# **As-Built Baseline Monitoring Report**

## **Russell Gap Mitigation Project**

**Subject:** Response to DMS Comments for DRAFT As-Built Monitoring Report  
Russell Gap Mitigation Project, Alexander County  
DMS Project # 100003, DEQ Contract #6980, Catawba River Basin

Please find enclosed our responses to the NC Division of Mitigation Services (DMS) review comments dated August 28, 2020 in reference to the Russell Gap Mitigation Project - DRAFT As-Built Monitoring Report. We have revised the draft document in response to the review comments as outlined below.

Russell Gap Rd

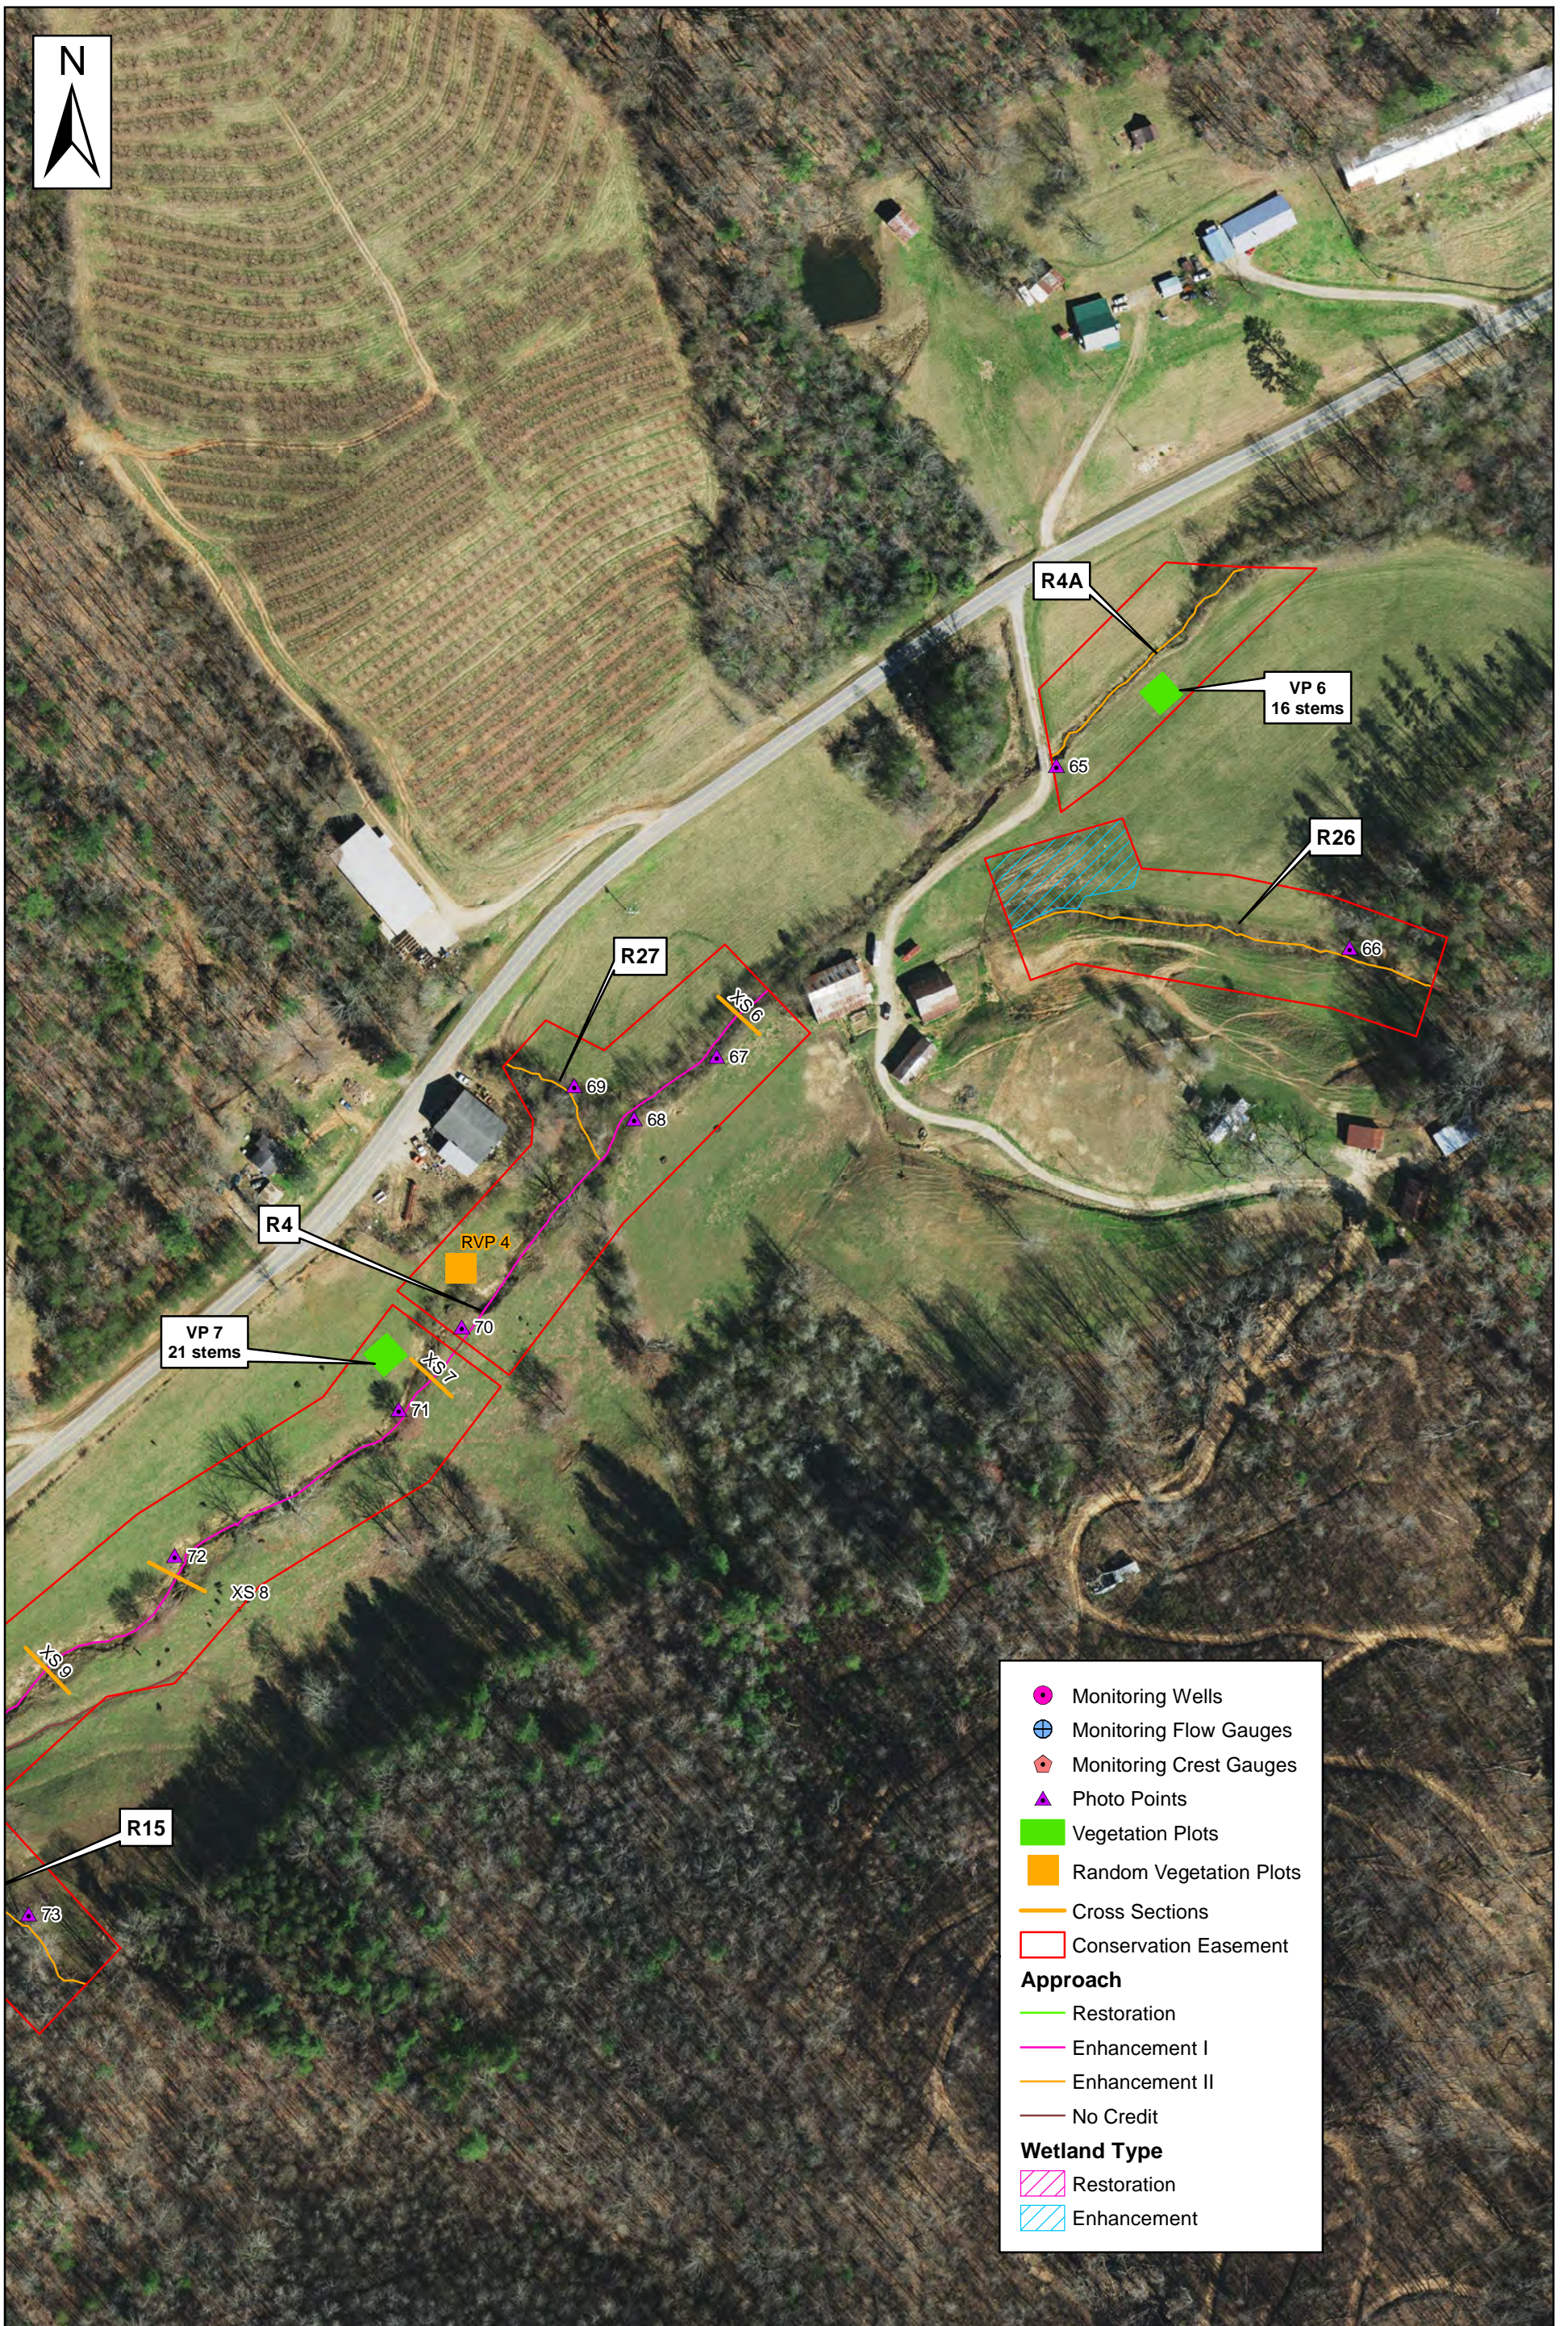
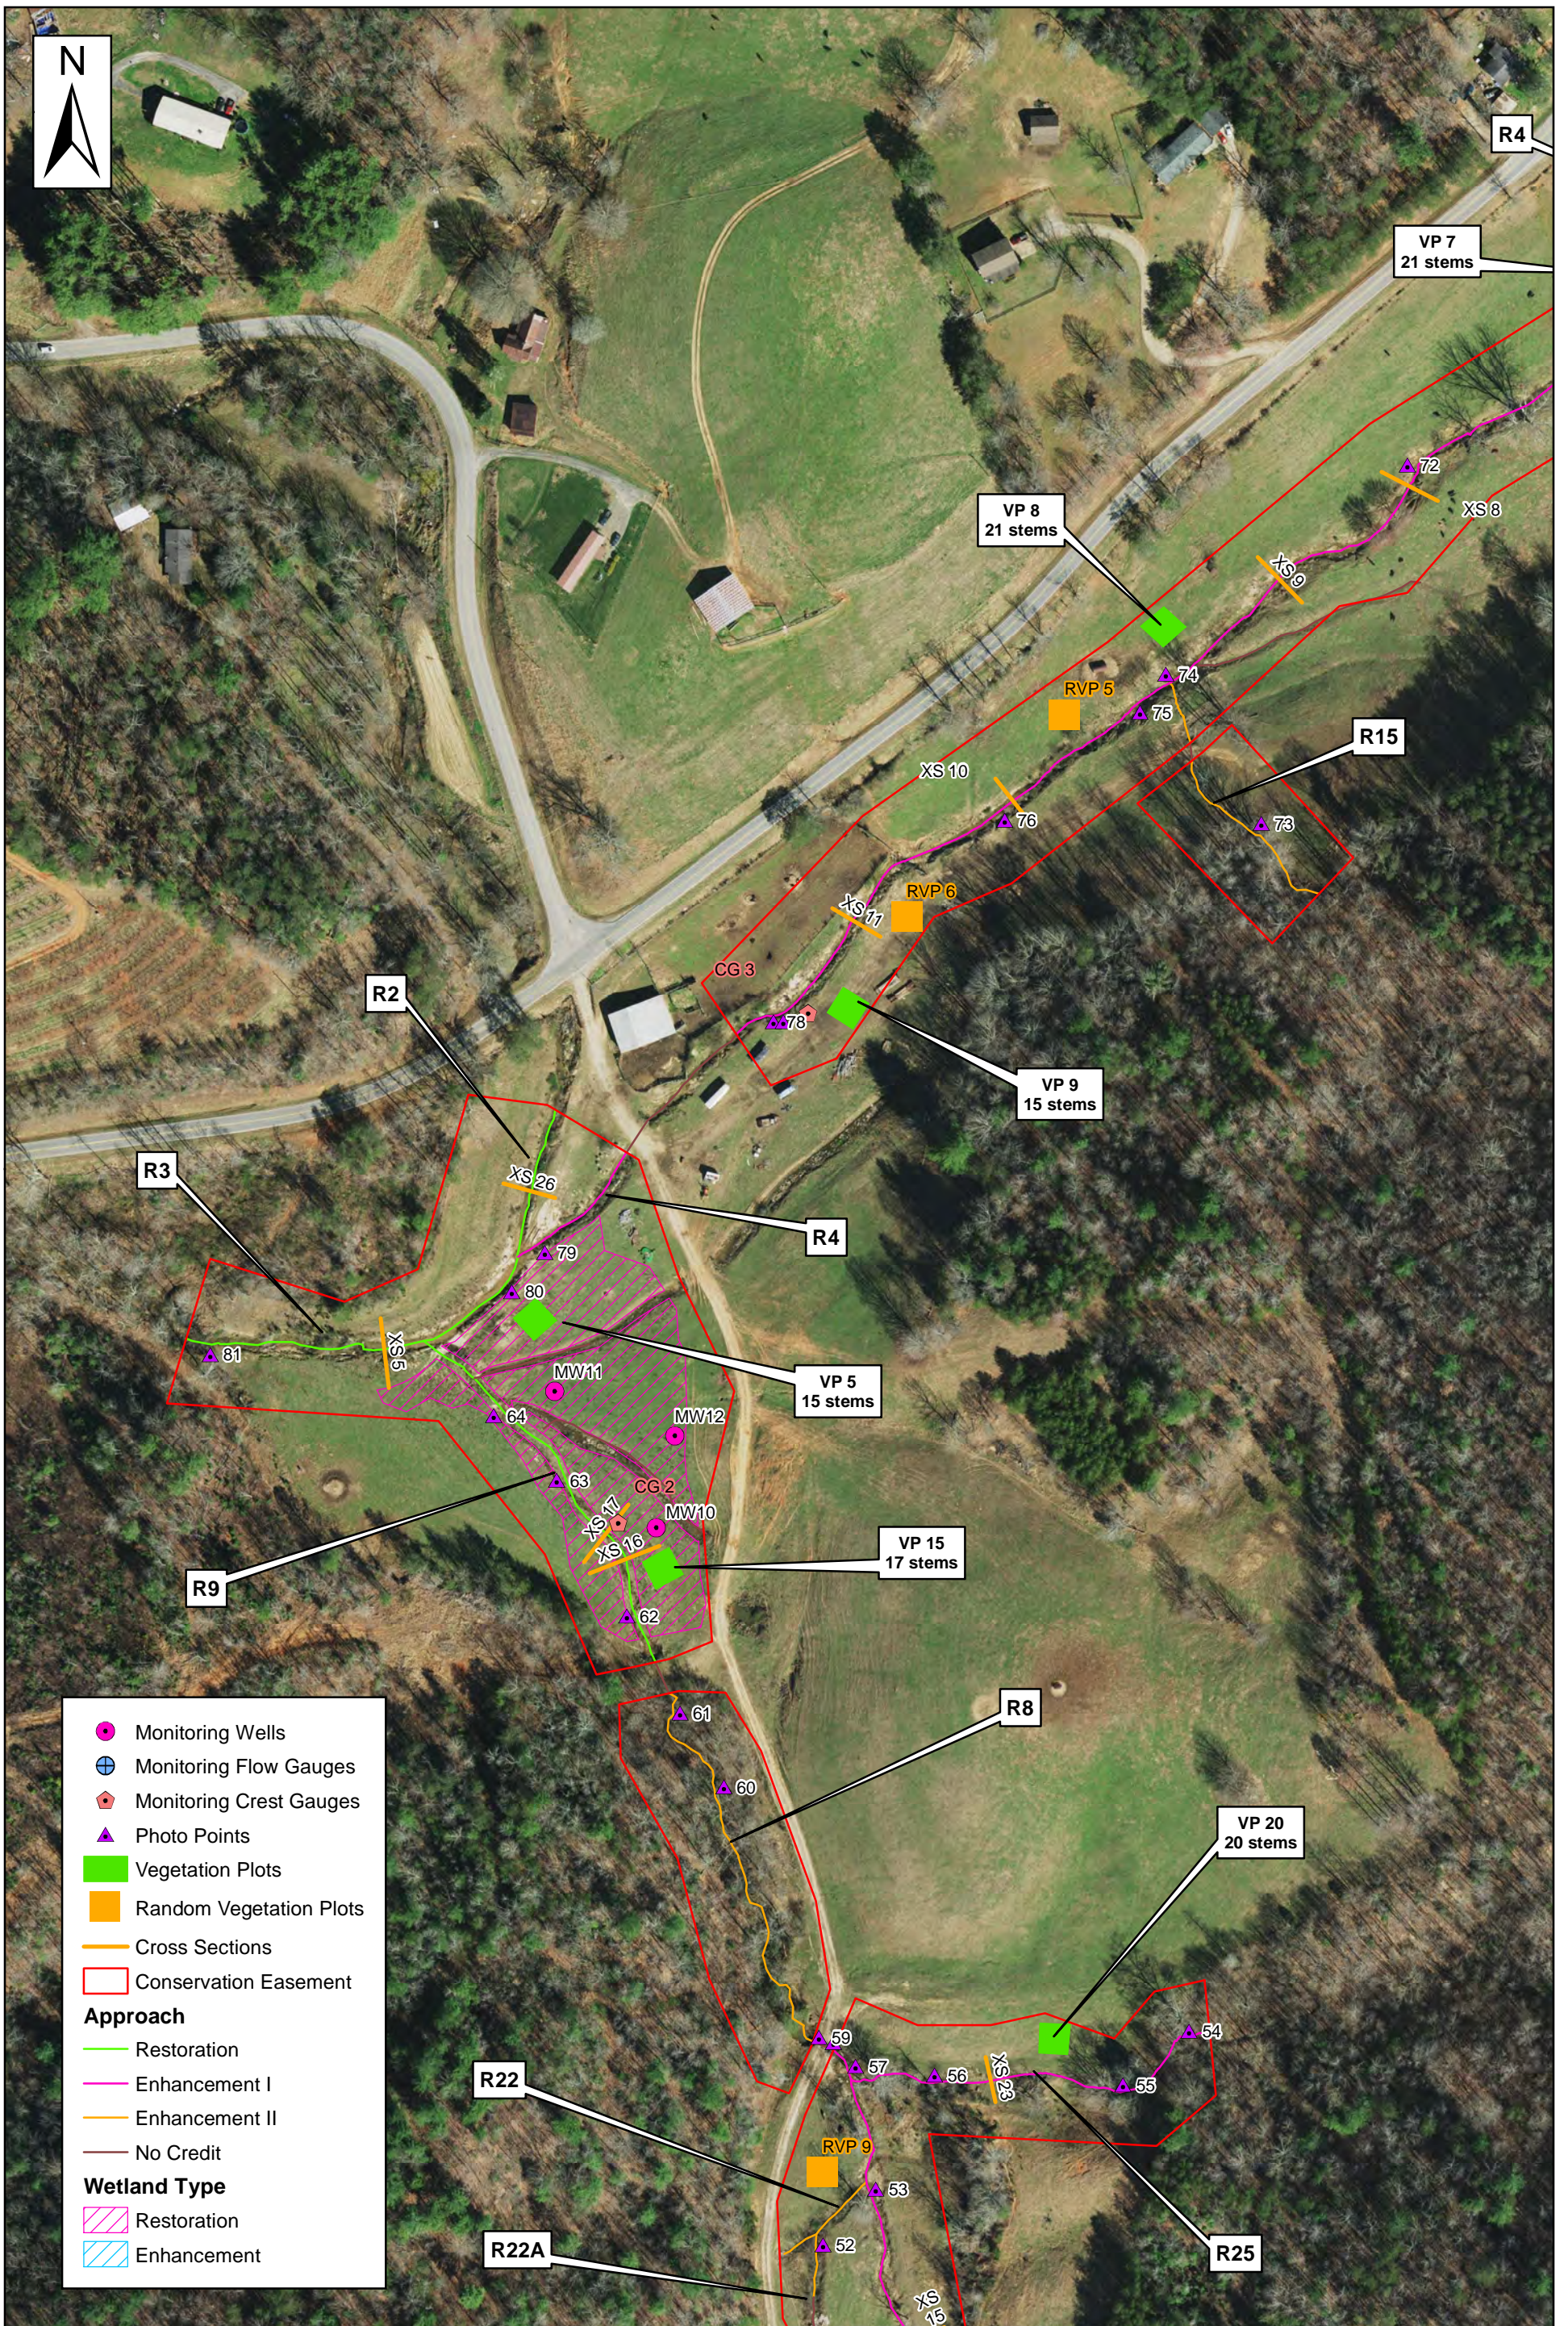
**Response: Revision made as requested.**
- Figure 3: Please add location of Random Vegetation Plot to CCPV.  
**Response: Revisions made as requested.**

- Figure 3B: Label XS8  
**Response: Revision made as requested.**
- Figure 3C: Label XS8, XS10  
**Response: Revisions made as requested.**
- Figure 3D: Label XS21, XS22

**Response: Revisions made as requested.**
- Stream Station Photo Points: Photo resolution is very poor in the draft report. Please update for final.  
**Response: All stream photos have been redownloaded and updated into the final report as requested.**
